**ADDENDUM NUMBER THREE
TO PLANS AND SPECIFICATIONS**

**NEW COMPLEX FOR WASHINGTON COUNTY ROAD & BRIDGE
BRENHAM, TEXAS**

October 25, 2018

SHEET NUMBER	SHEET NAME
C100	SITE PLAN
DATE	
09.28.18

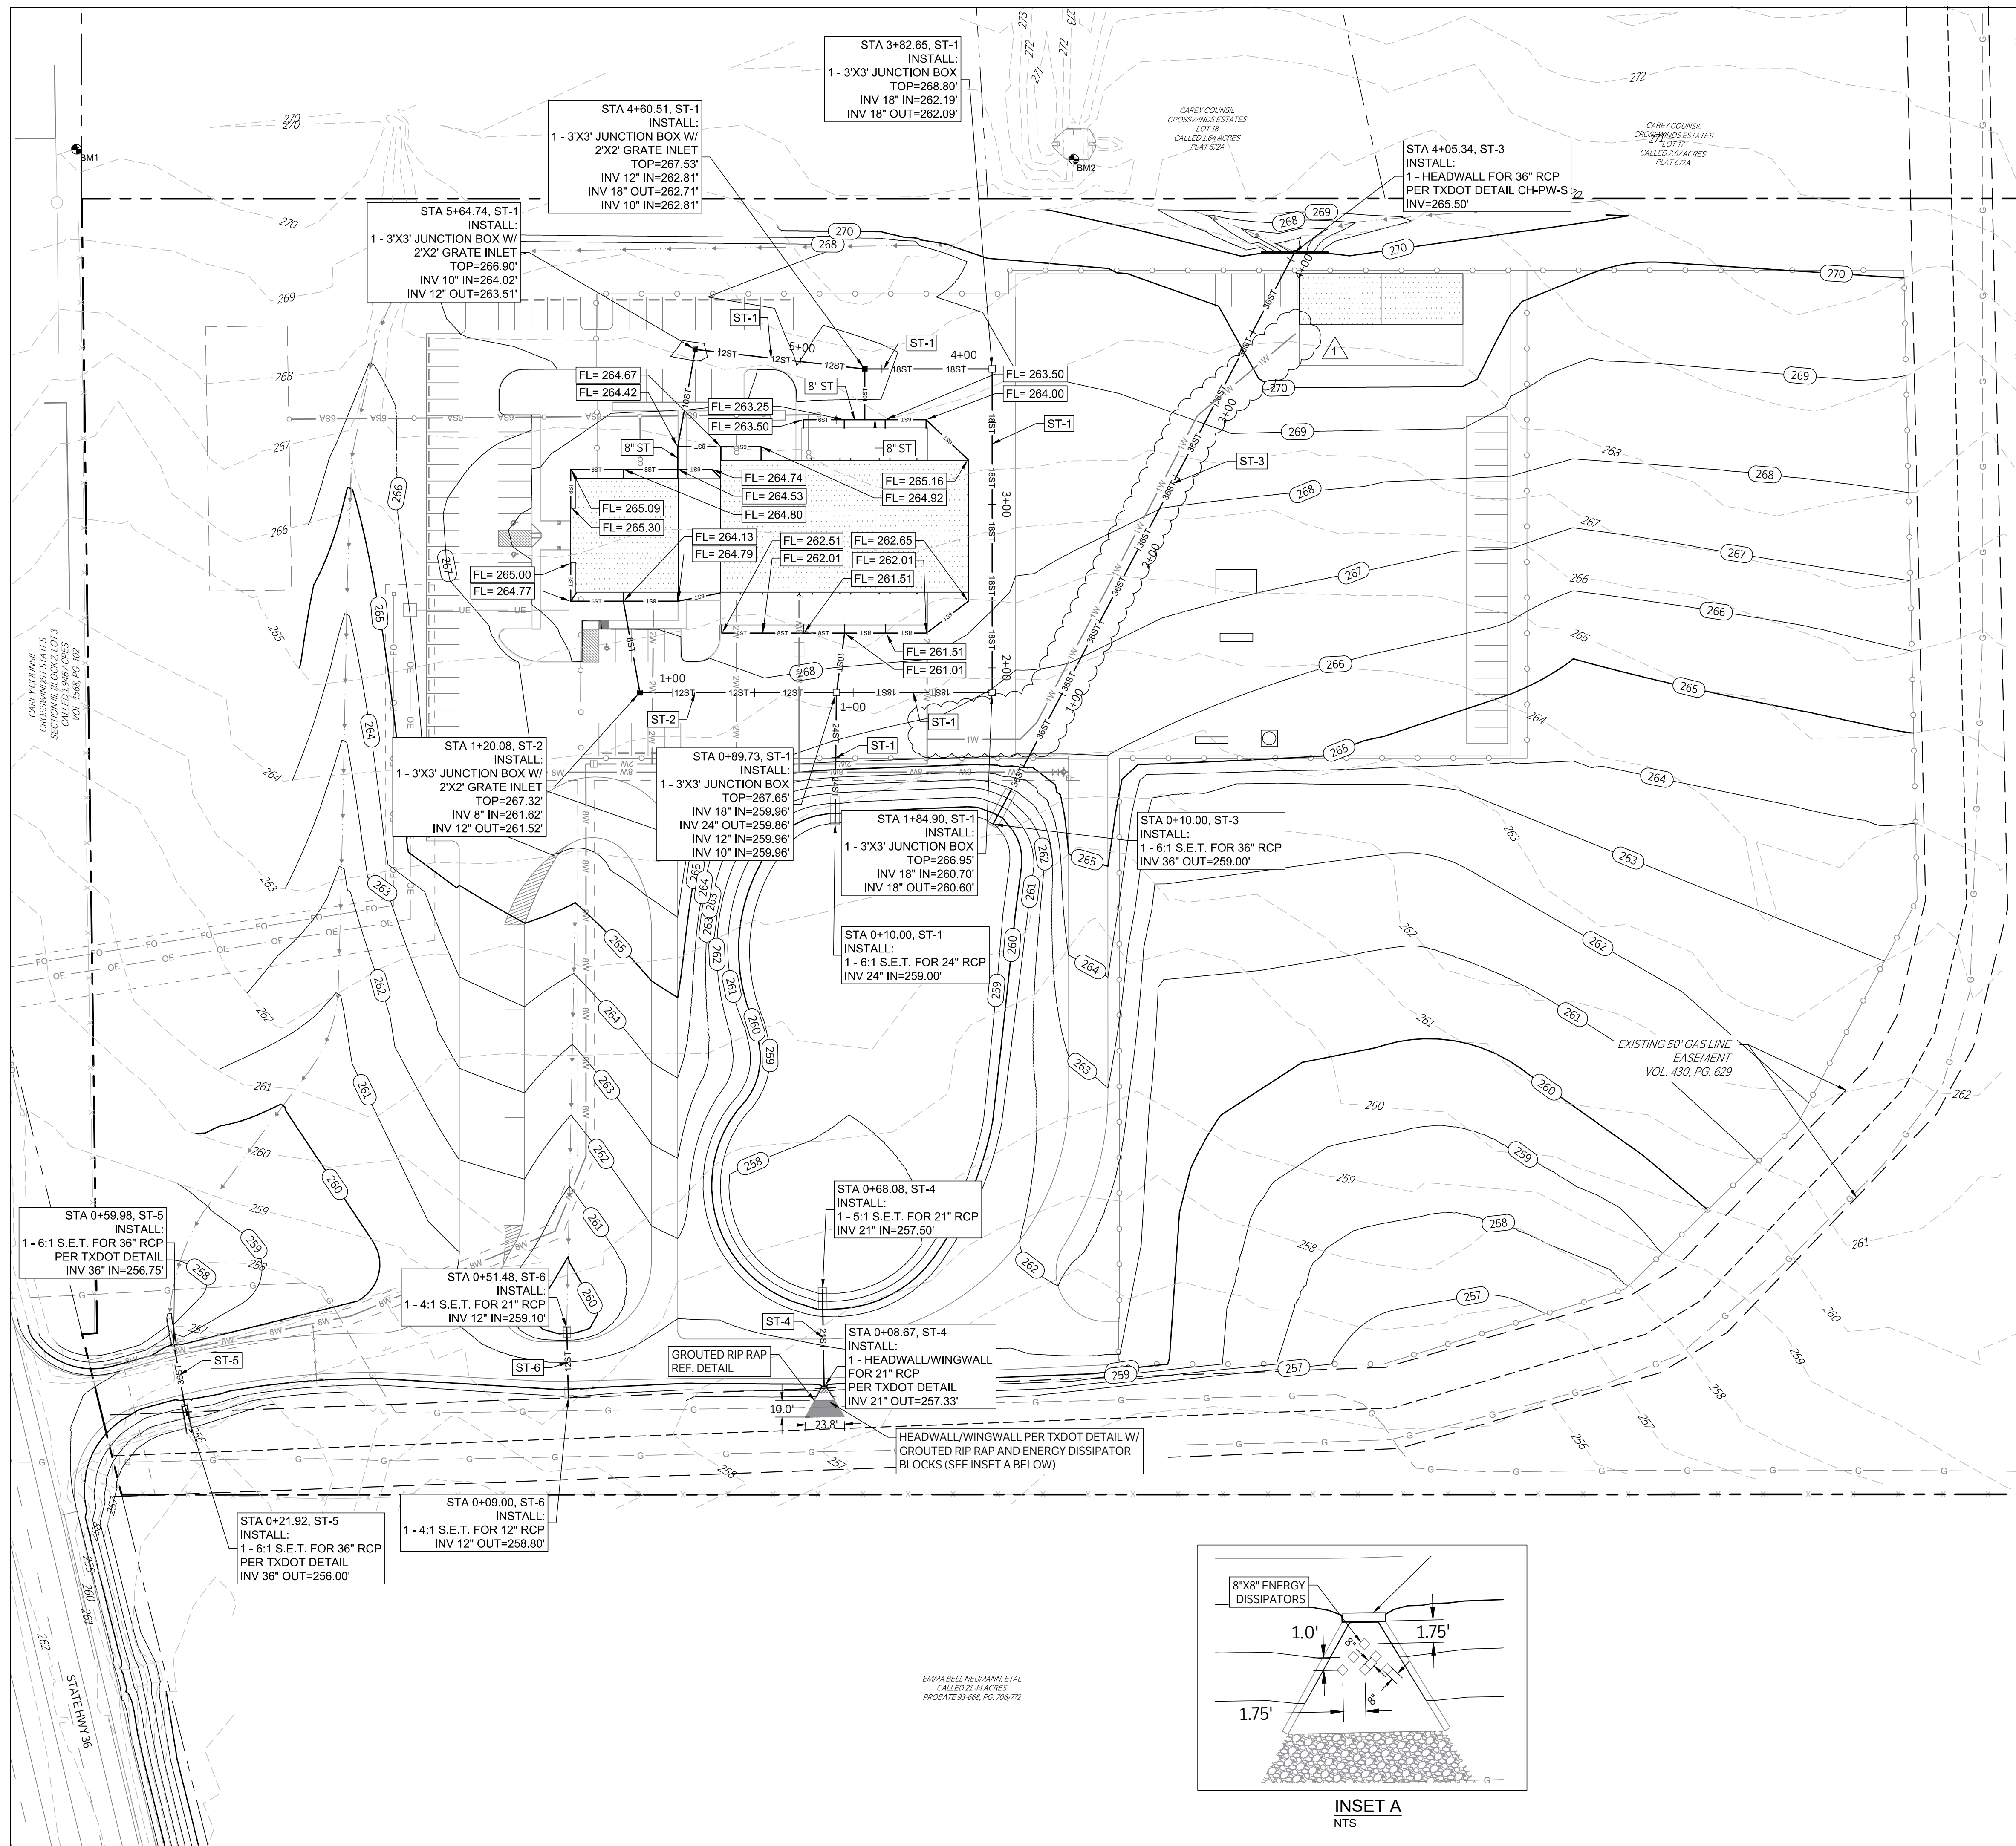
1. On sheet C100 the "Proposed Fiber Optic Line to be Coordinated w/Housley Communications" is to be coordinated by contractor during construction but will not be furnished and installed in this contract.
2. O.S.S.F indicated on sheet C100 to be designed, furnished and installed in this contract.
3. All proposals shall abide by the Davis Bacon Act. Reference the attachment and refer to the website provided for detailed information regarding Davis Bacon.

8. C100 SITE PLAN, C700 STORM PLAN, C800 UTILITY OVERALL, C1000 WATER PLAN– Add 1" water line to "Proposed Sign Shop". Replace Sheets C100, C700, C800, C1000.
9. C1000 WATER PLAN – Add Vault for Double Check Valve. Replace Sheet C1000.
